THE CITY OF KEY WEST
PLANNING BOARD
Staff Report

Agenda Item: **Variance – 10 Lowes Lane (RE# 00007530-000000)** – A request for a variance to the minimum required front, side, and rear setbacks, and the minimum required open space in order to remodel an existing single-family home on a parcel located within the Historic High Density Residential (HHDR) zoning district pursuant to Section 90-395, 122-630(6)a., 122-630(6)b., 122-630(6)c., and 108-346(b) of the Land Development Regulations of the City of Key West, Florida.

Existing and Proposed First Story Floor Plan

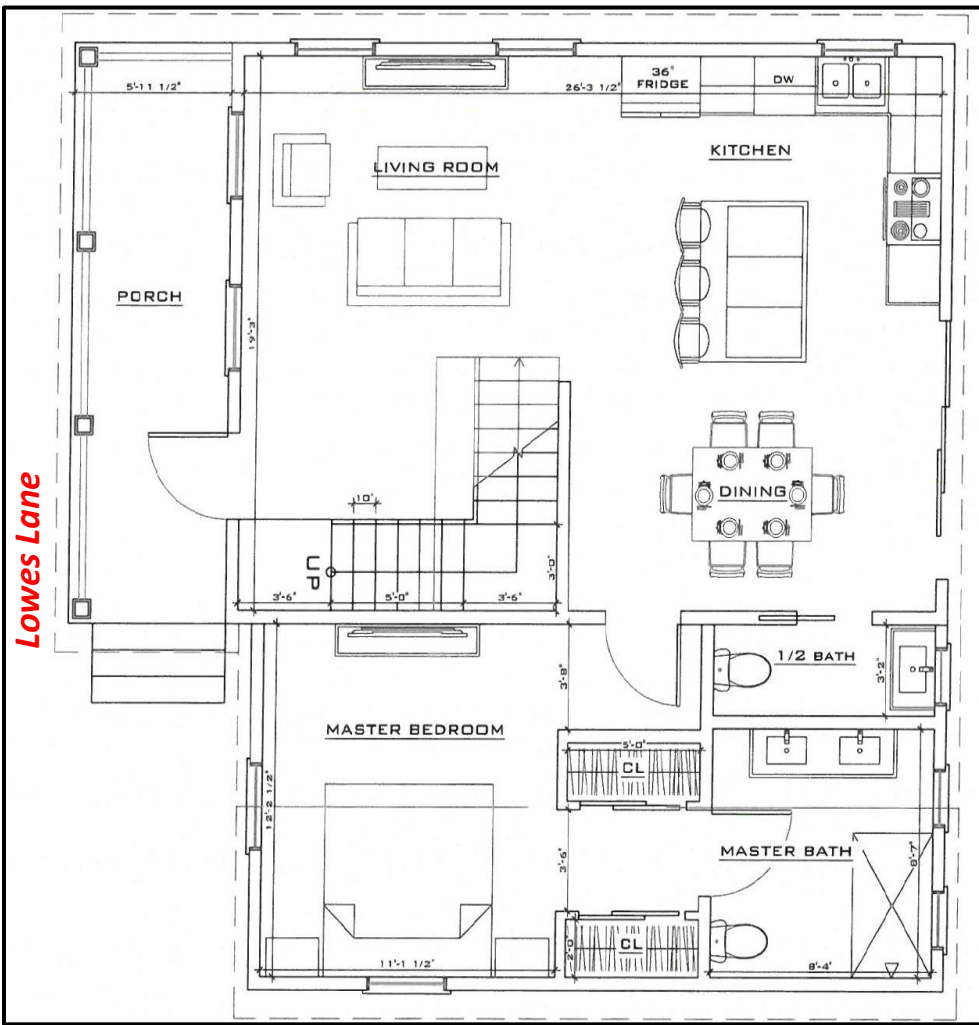
Red square indicates area to be demolished on the first floor.

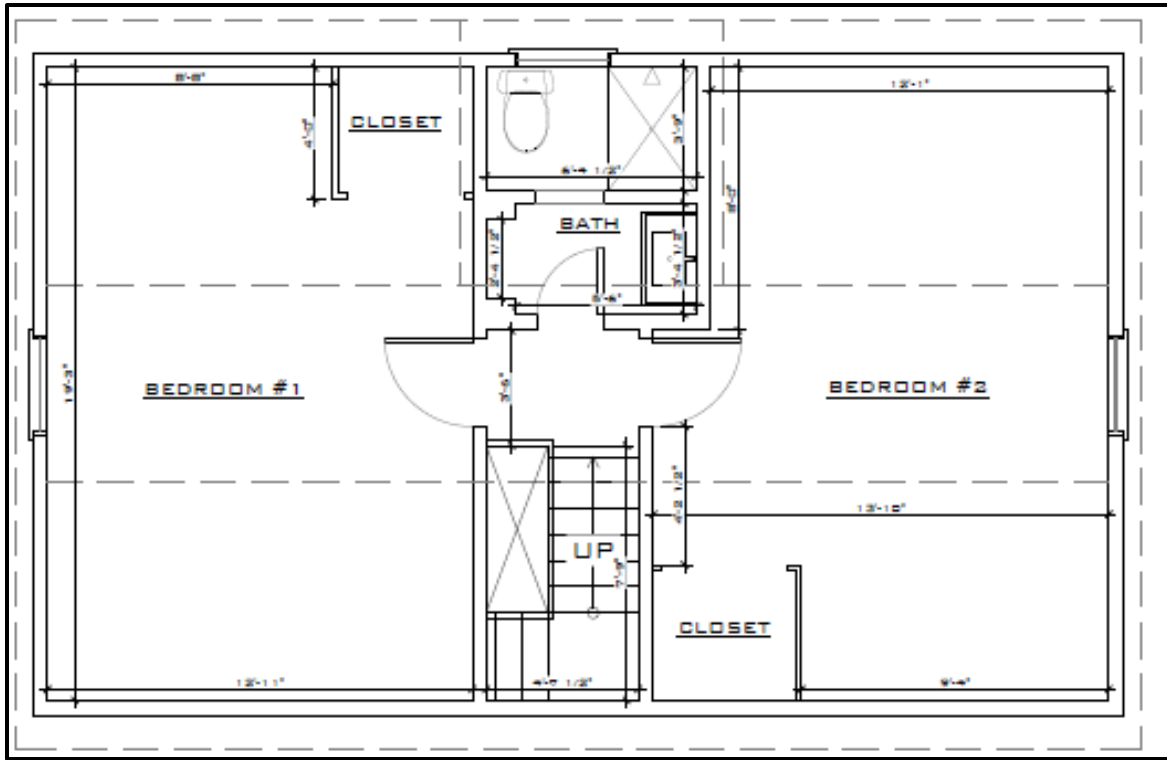
Proposed first story floor plan includes a master bedroom, master bathroom, and 1/2 bath to be constructed within the required front and rear setbacks.

Existing and proposed front elevation

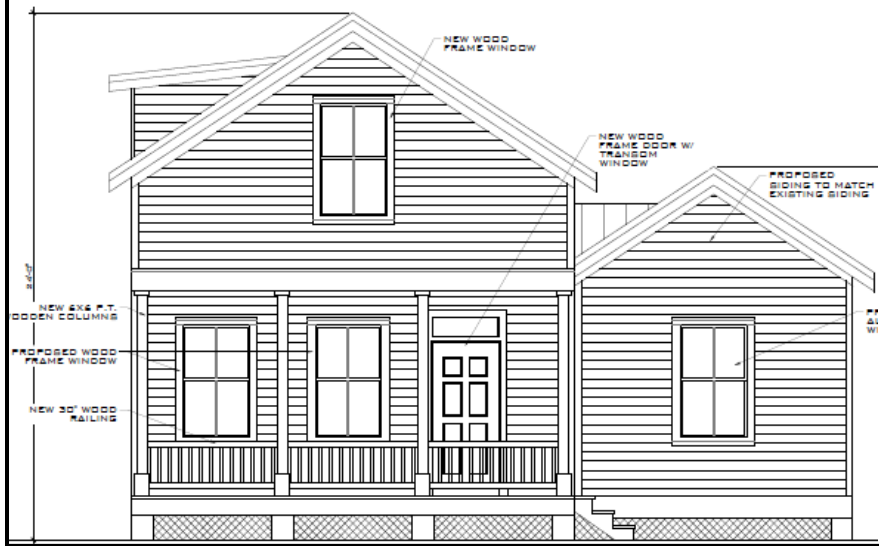
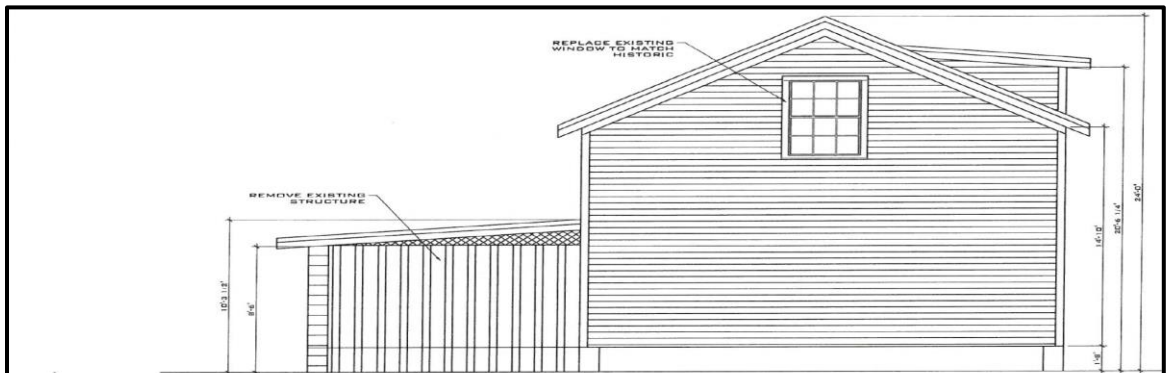
Plans depict existing covered porch will be demolished and reconstructed into habitable space. The front of the structure will be opened to allow for a new porch, though the existing 0'-0" setback and 0.7' overhang over City right-of-way will remain.

Existing and proposed rear elevation

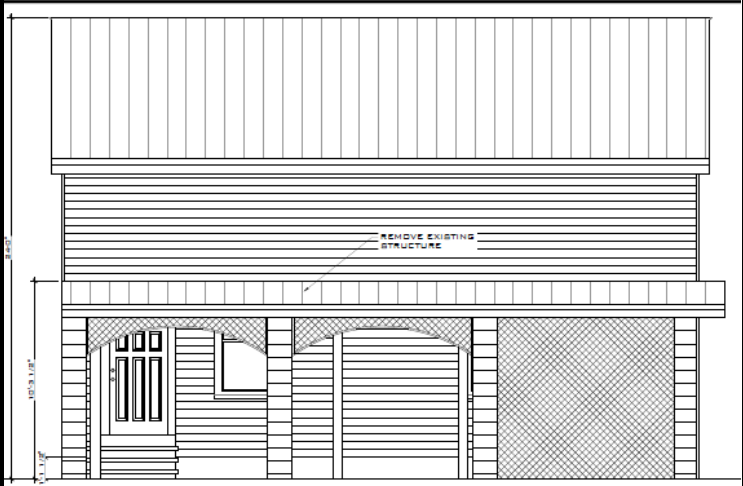
Plans depict new structure elevated 1'-8".

Existing and proposed east-side elevation

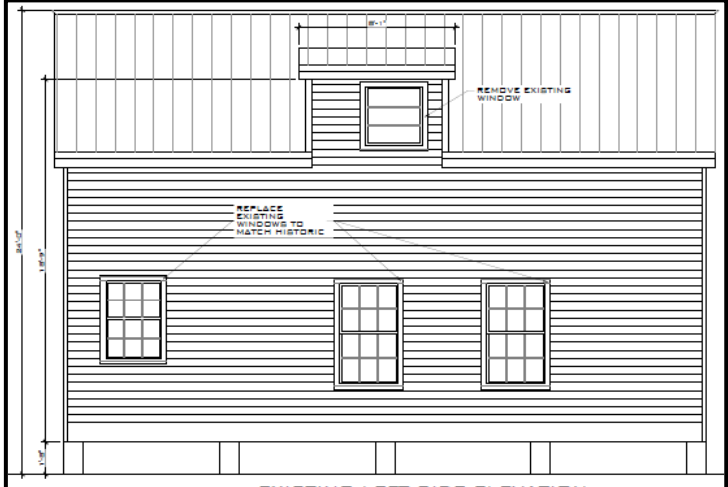
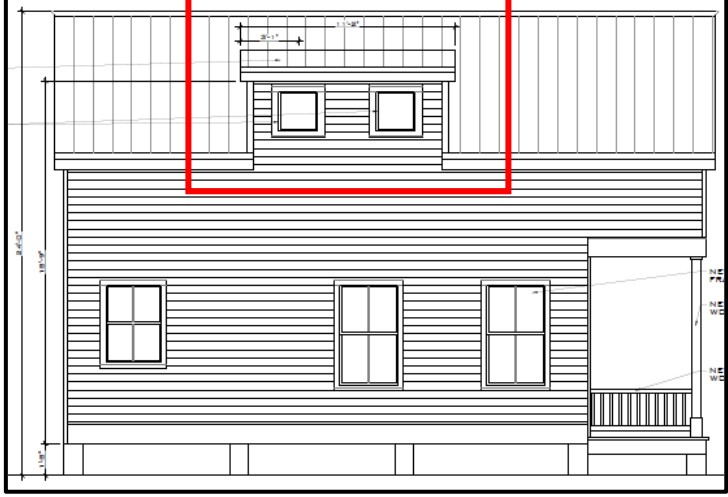
Red square indicates dormer site work area.
